**Provo City Landmarks Commission Staff Report  
Certificate of Appropriateness for Addition  
Hearing Date: June 18, 2008**

The applicant is seeking a certificate of appropriateness for an addition to a Landmarks Register property generally located at 589 East Center and commonly referred to as the Fred Taylor house.

Bedroom, Bath, Family Room Addition

1. Proposed elevation and work detail.

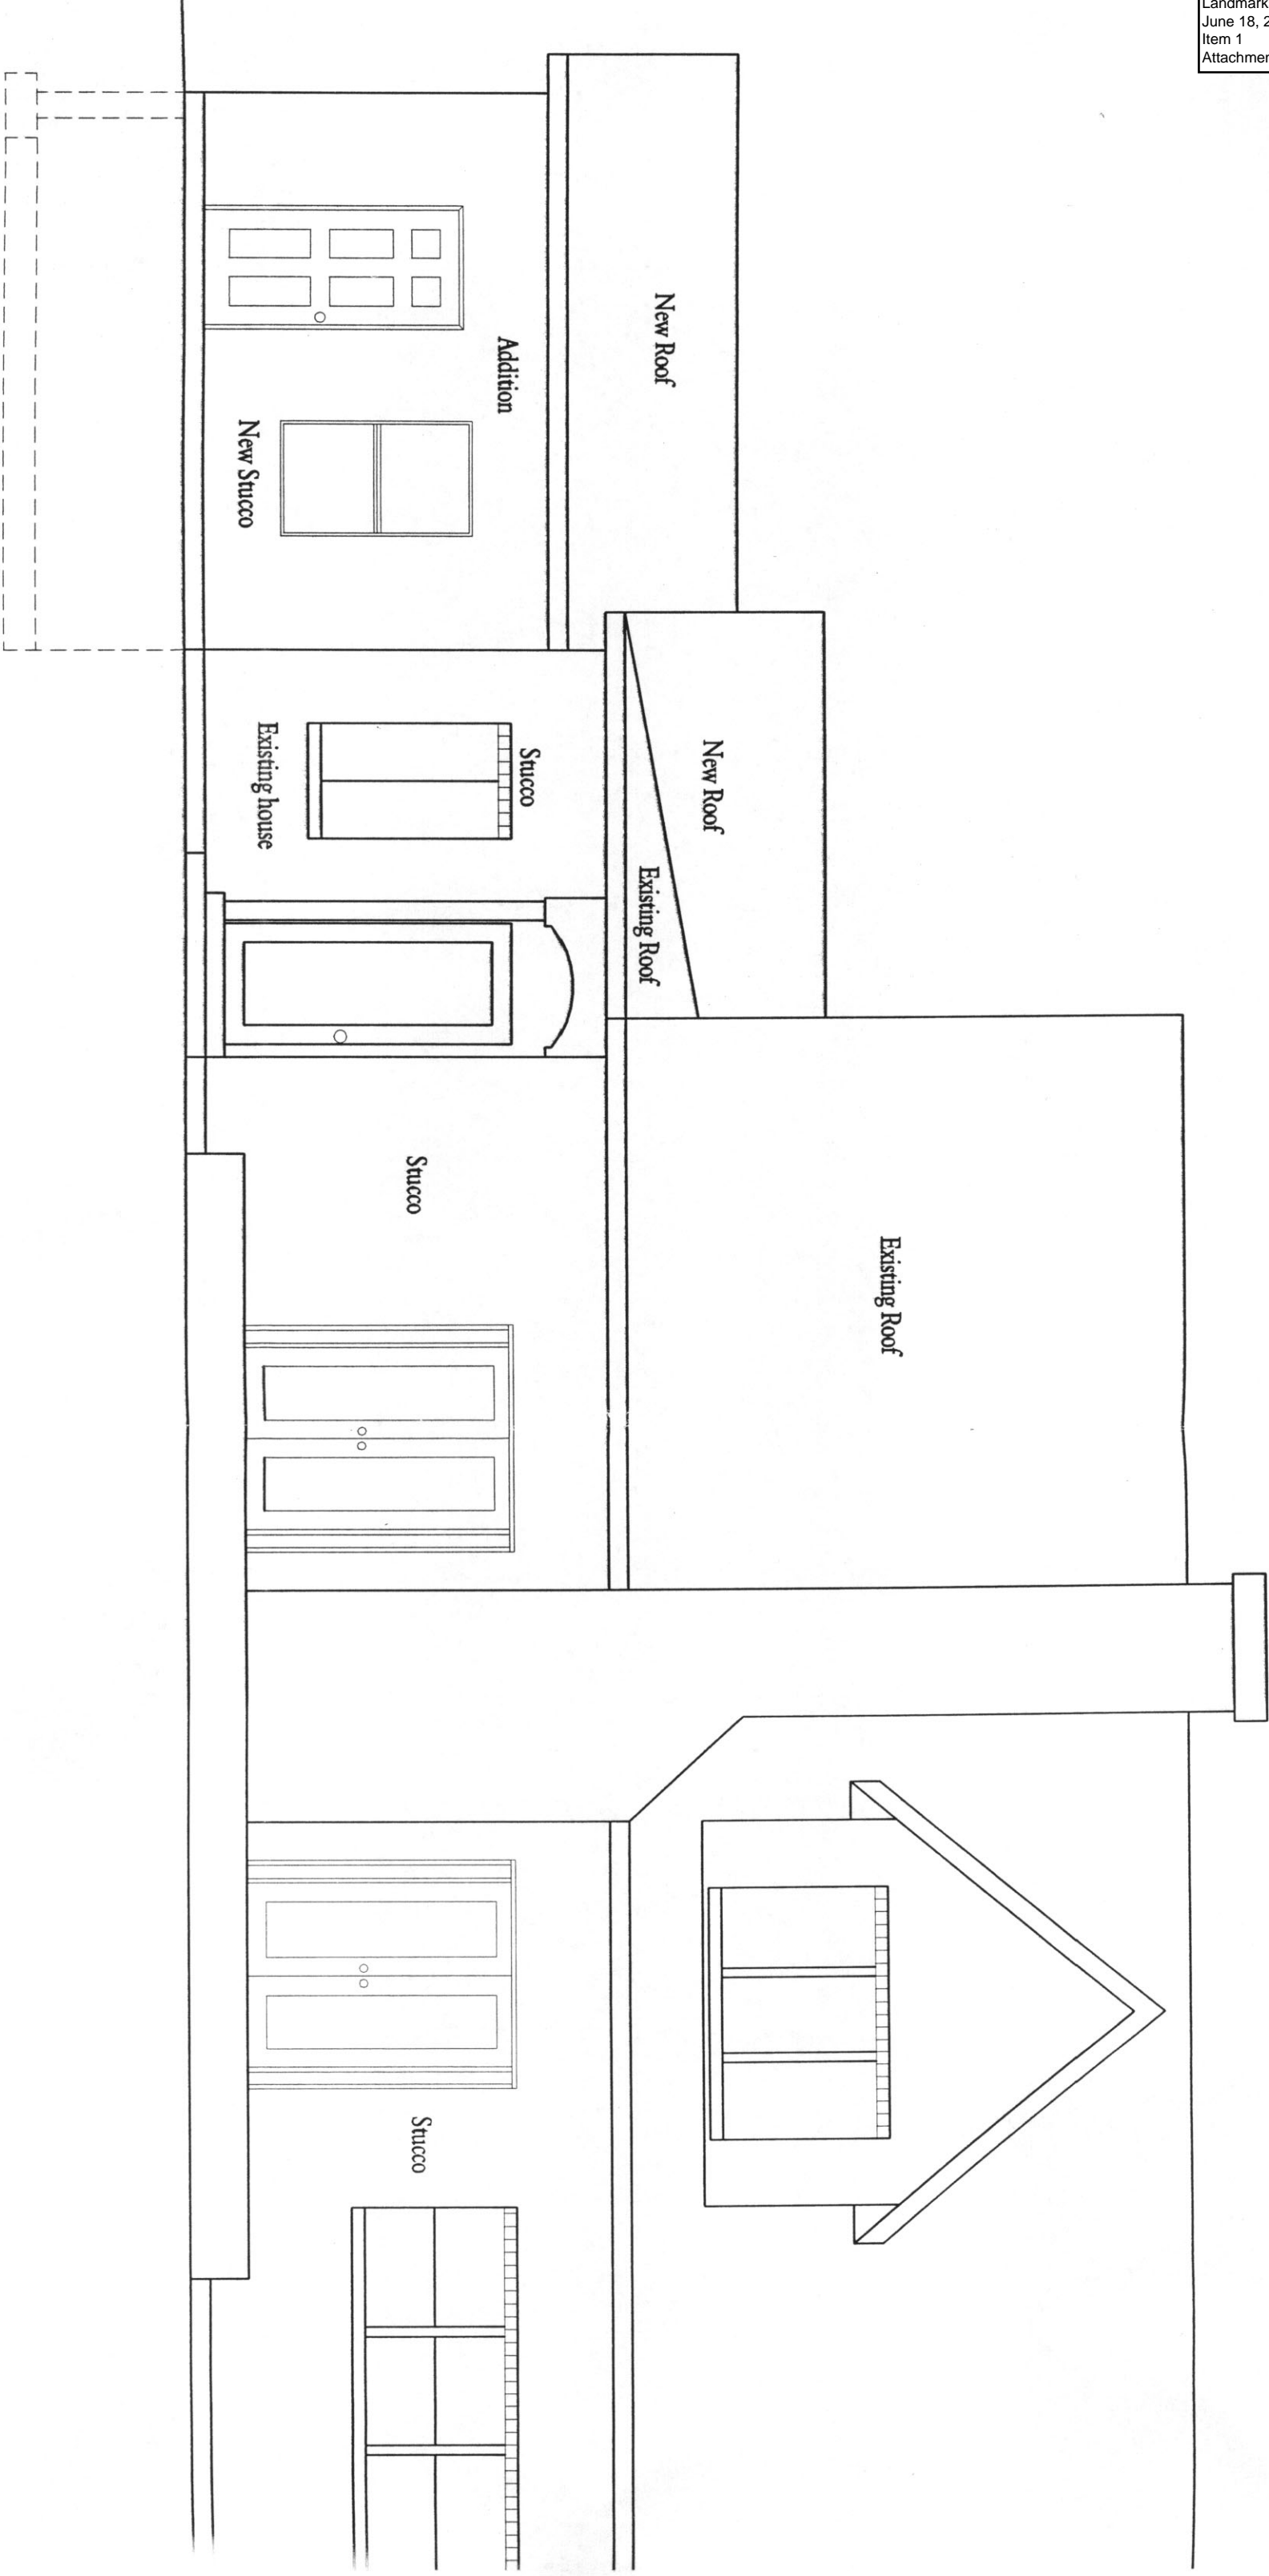
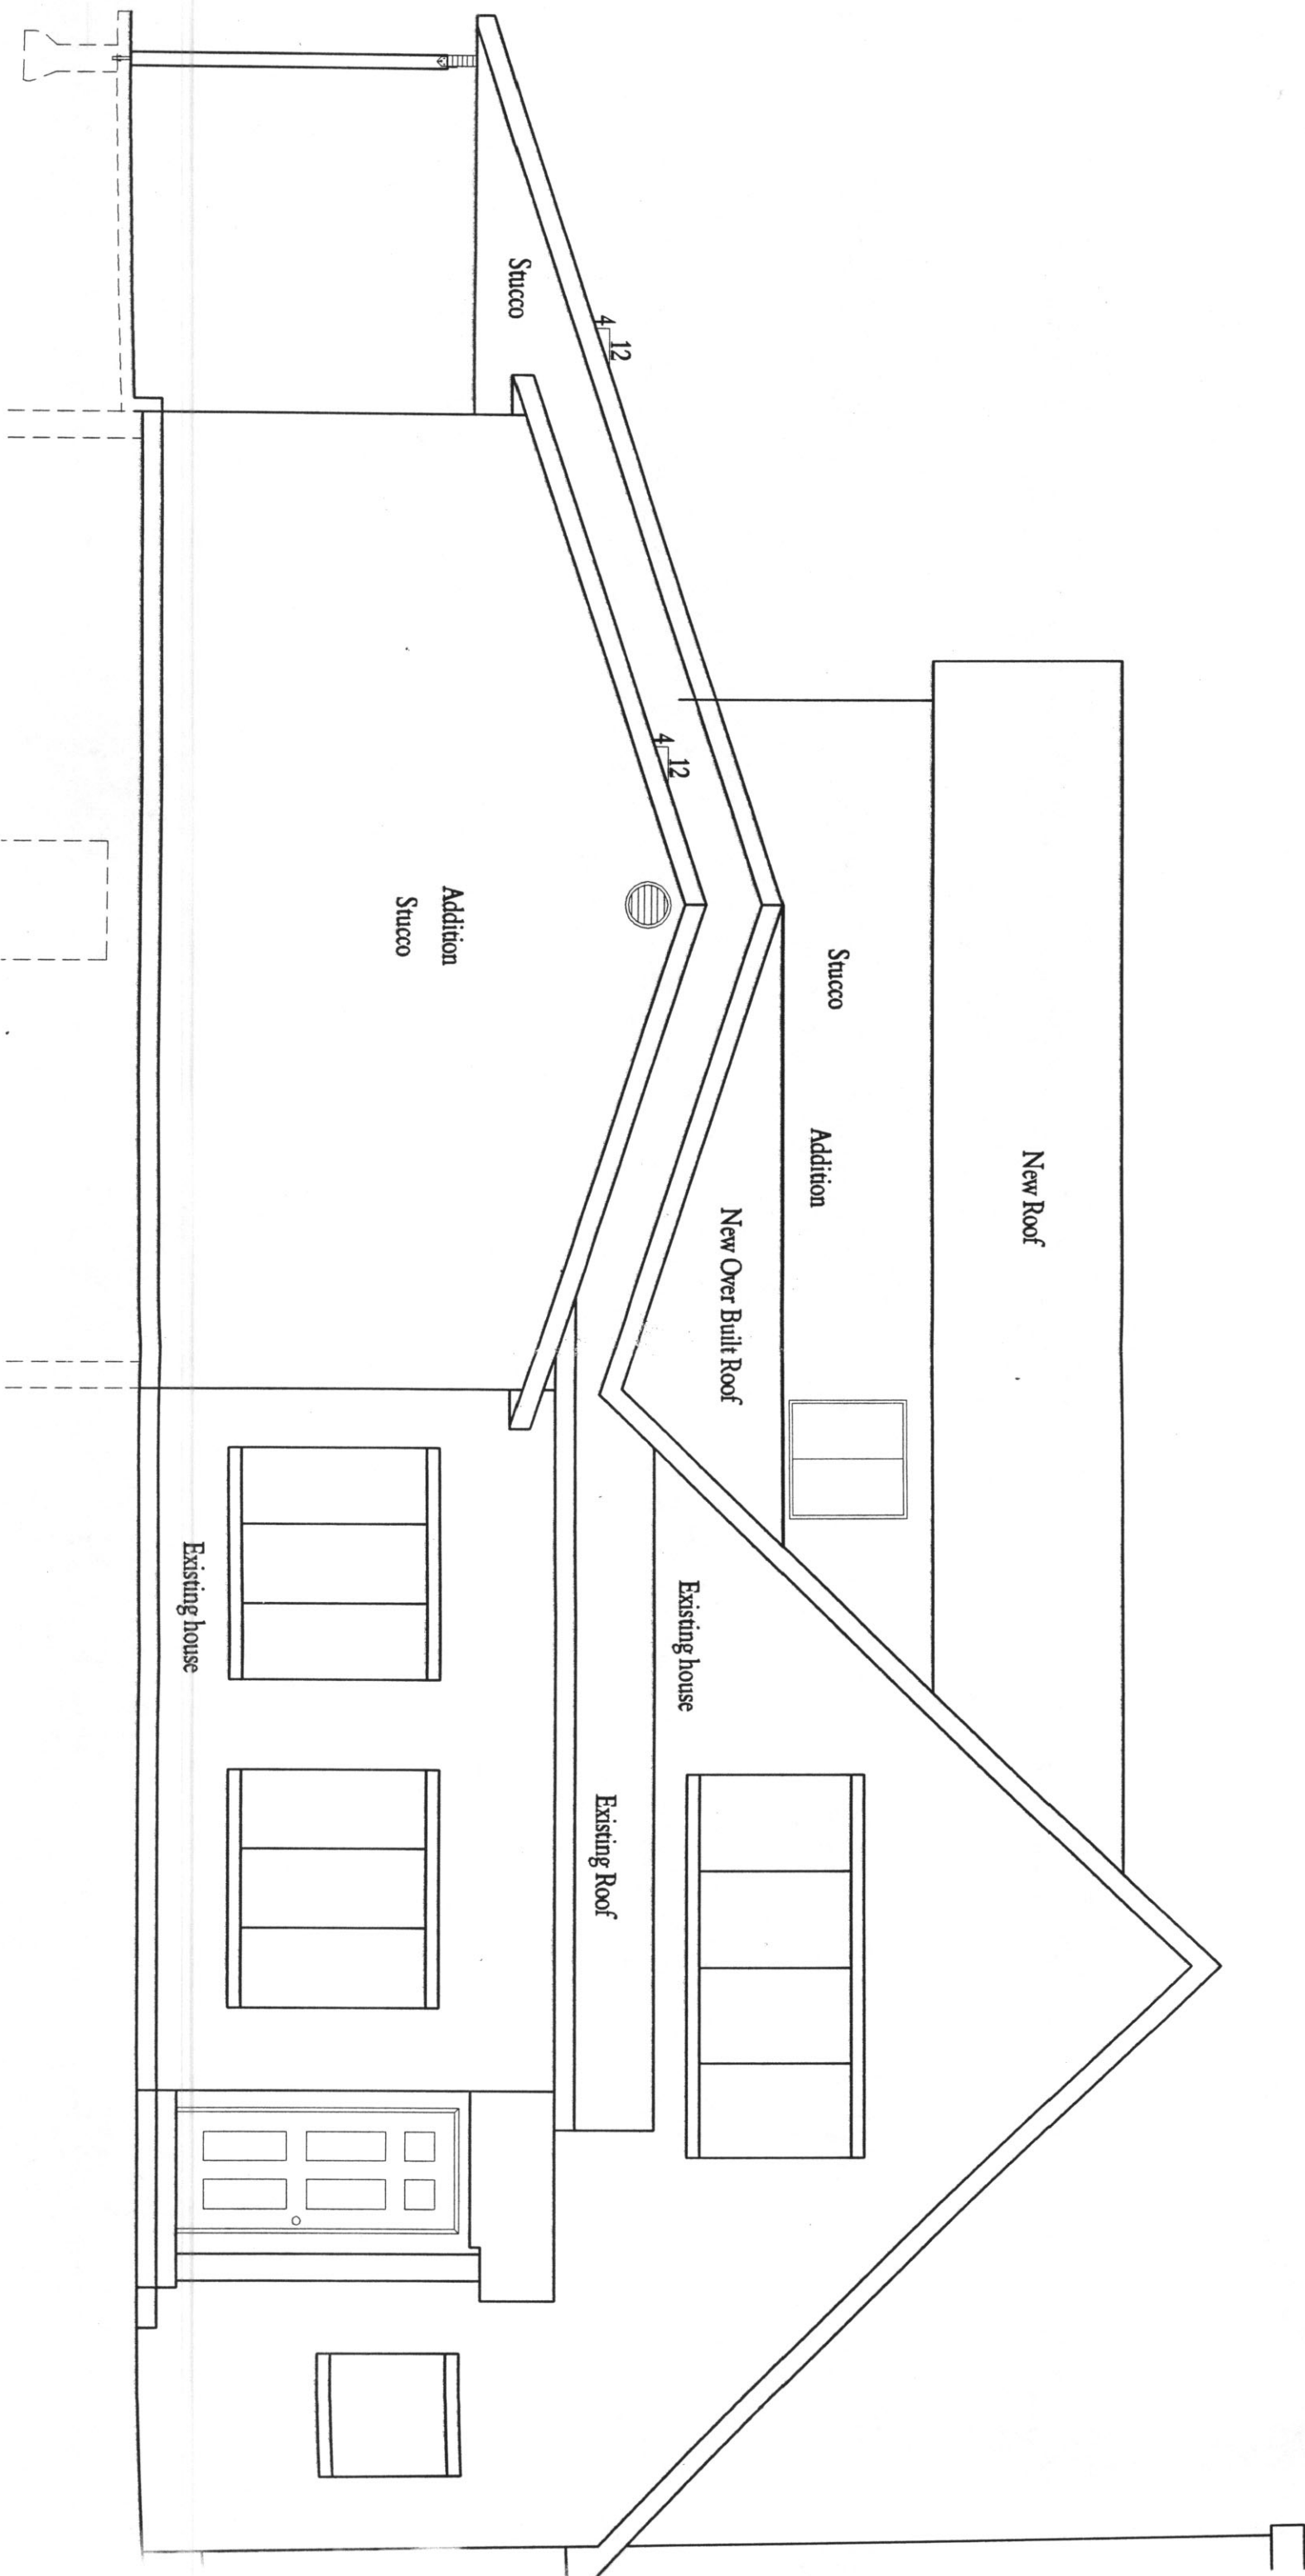
The majority of the proposed work will not affect the historical integrity of the Landmark Register property. However, standard number nine may not be satisfied: *New additions, exterior alterations, or related new construction shall not destroy historic materials that characterize the property. The new work shall be differentiated from the old and shall be compatible with the massing, size, scale, and architectural features to protect the historic integrity of the property and its environment.* .

It appears that the addition may not be distinguishable from the old construction. However, the addition is in the rear of the property and will generally not be viewable from the public.

Approve the requested for a Certificate of Appropriateness.
